**BEFORE THE PUBLIC UTILITIES COMMISSION  
OF THE STATE OF CALIFORNIA**

Rulemaking 13-12-010  
(Filed December 19, 2013)

**COMMENTS OF THE CALIFORNIA WIND ENERGY ASSOCIATION  
ON REPORT OF SOUTHERN CALIFORNIA EDISON COMPANY ON INTEGRATION  
COST STUDY FOR 33% RENEWABLES PORTFOLIO STANDARD**

*Figure II-3*

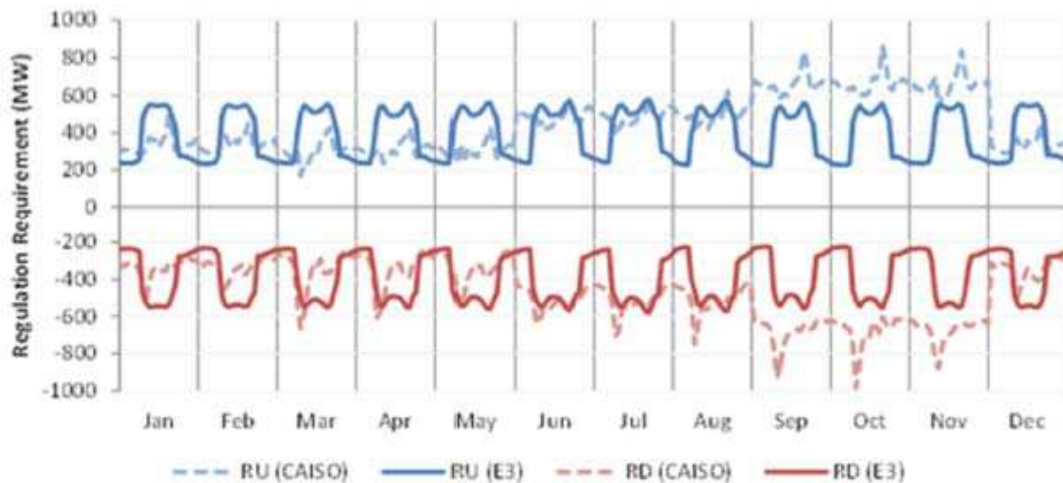
Figure II-3 in the SCE Report (reproduced below) shows substantially different results between the CAISO's<sup>1</sup> and E3's studies of regulation requirements for 33% renewables, yet the report states (at p. 11) that the "overall level and the trends observed for regulation requirements are generally consistent" between two studies, and E3's results are used. This statement requires further justification, since using E3's results could significantly underestimate regulation capacity needs, particularly for solar PV generation and when compared with results from the CAISO's earlier 33% renewables integration studies.
